Interactive comment on “Impact of climate forecasts on the microbial quality of a drinking water source in Norway using hydrodynamic modelling” by Hadi Mohammed et al.

Received and published: 16 November 2018

Fig. 1. Ice cover on lake surface from 9th February to 13th February and 14th to 16th February 2017.

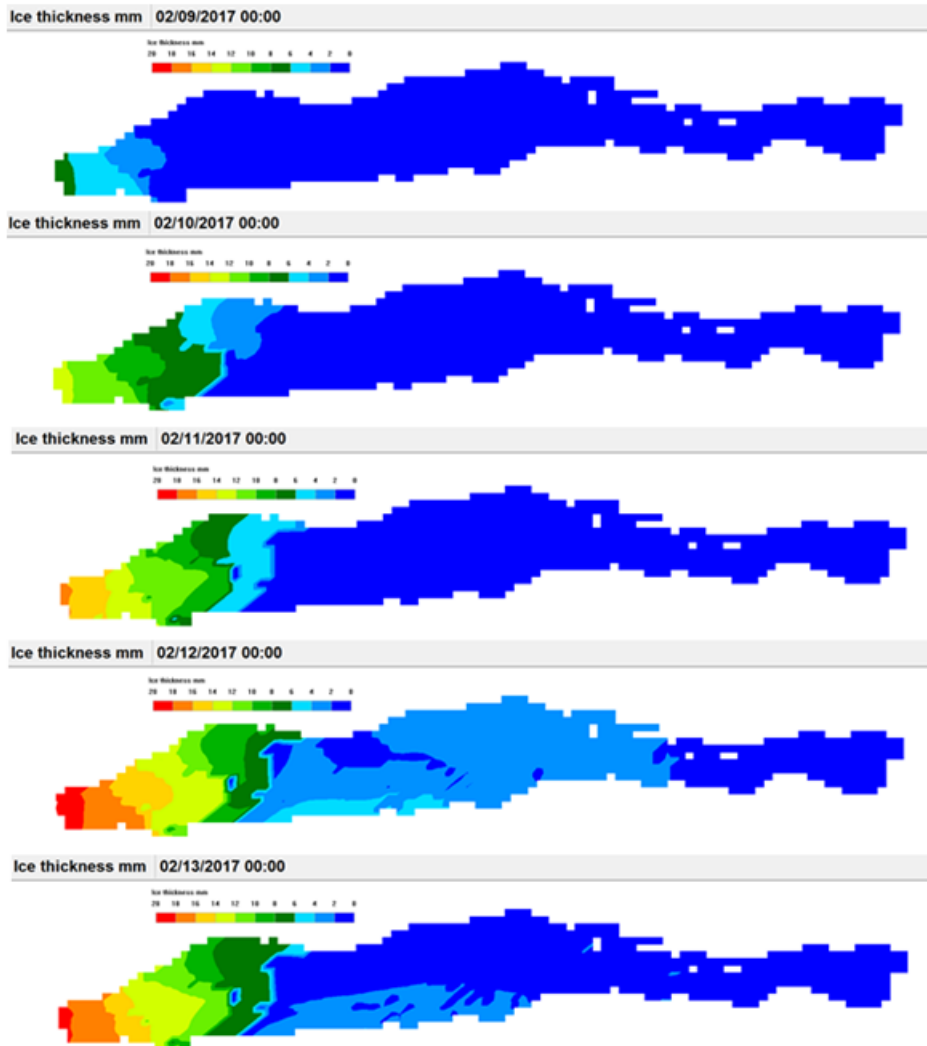
Response to Comment #17. The model predicts ice cover. However, data on ice cover

was not available for comparison, thus, the output was not presented in this work.

The modelled Lake (Brusdalsvatnet) is located in a mild coastal climate, where ice-forming is not as common and long-lasting as in most other lakes in Norway, therefore, the Lake is never fully covered by ice. The mild climate prevents long periods of cold weather, which is needed to form a stable long-lasting ice cover. Therefore, ice normally only covers smaller portions of the Lake and for short time periods. The model result regarding ice cover is shown in the figures attached.

The figures below show ice cover on the Lake surface predicted by the model in 2017. The ice started appearing on 9th February and ended after 16th February. Ice was formed again on the 7th of March and ended after March 9th.
